PUBLIC UTILITIES COMMISSION

RE: Minor Project Modification #7 for the Fulton-Fitch Mountain Reconductoring Project

MINOR PROJECT REFINEMENT REQUEST FORM

MINOR PROJECT REFINEMENT REVIEW FORM

Figure 1: Map and Photo

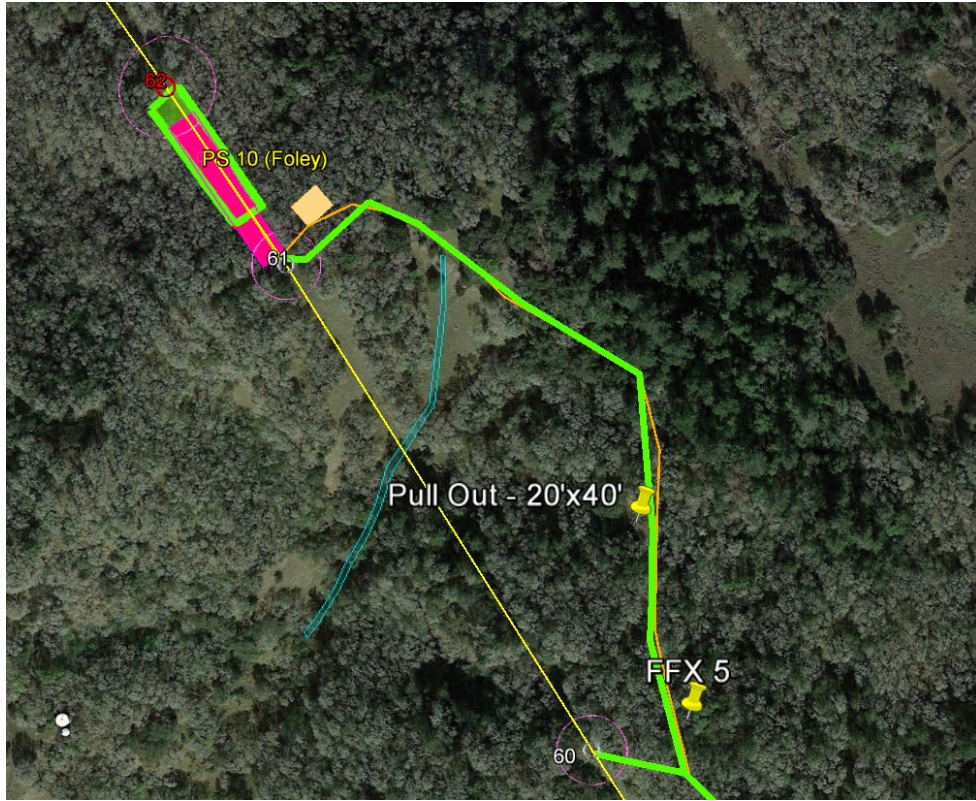
This minor project refinement serves as a request from PG&E to mow a 20' x 40' area on the shoulder of existing access road A36 (access road to PS-10) to allow a pull-out for vehicles. Gravel would be applied temporarily but no grading would occur. The pullout is located at 38.571053, -122.791597.

The project would be using the area to allow large haul trucks and line trucks to get safely off the access road and allow other traffic to get past.

Figure 1: Map and Photo

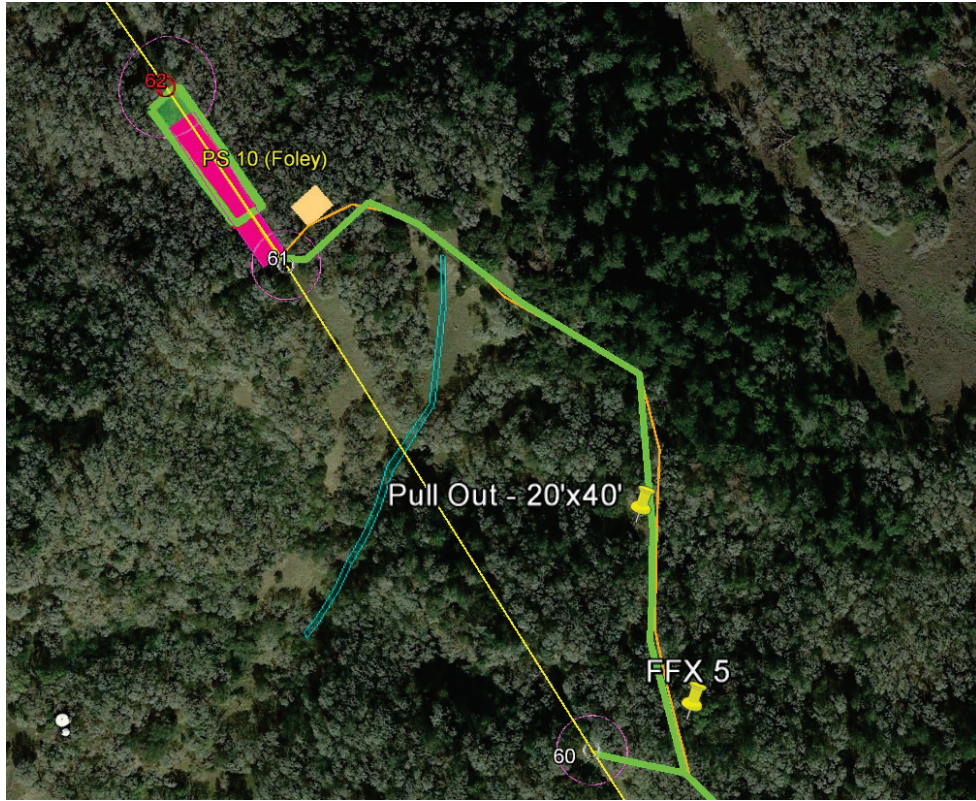
PG&E requests to mow a 20' x 40' area on the shoulder of existing access road A36 (access road to PS-10) to allow a pull-out for vehicles. Gravel would be applied temporarily but no grading would occur. The pullout is located at 38.571053, -122.791597.

The proposed turnout is within the IS/MND study area and was previously surveyed for special-status species. The site is within Oregon oak woodland (see Table 1), which is a designated sensitive natural plant community and which may provide suitable habitat for the same special-status species evaluated in the IS/MND. The site would be mowed and covered with gravel; no impacts to trees would occur. Vegetation resources at the site were documented (see Table 1), and any impacts to vegetation resources would be temporary. After construction the site would be restored to pre-construction conditions in accordance with MM Biology-7 and MM Biology-9. Use of the proposed turnout would not result in new or substantially greater impacts on special-status species or sensitive natural plant communities beyond those analyzed in the IS/MND. Mitigation identified in the IS/MND would ensure all impacts remain less than significant, including APM BIO-7, APM BIO-8, APM BIO-9, MM Biology-2, MM Biology-3, MM Biology-4, MM Biology-5, MM Biology-6, MM Biology-7, MM Biology-8, and MM Biology-9.

The proposed turnout is located within the IS/MND study area and was previously surveyed for water resources. Seasonal watercourse SEW 27 is located within 500 feet of the proposed turnout. Use of the turnout has the potential to incrementally increase erosion at the site, which could affect water quality in the vicinity of the site in the same manner as other work areas for the project. Potential impacts on water quality would be reduced to less than significant through implementation of MM Hydrology-1, MM Hydrology-2, and the Stormwater Pollution and Prevention Plan. The proposed turnout would not result in a new impact or increase the severity of a previously analyzed impact on hydrology and water quality.
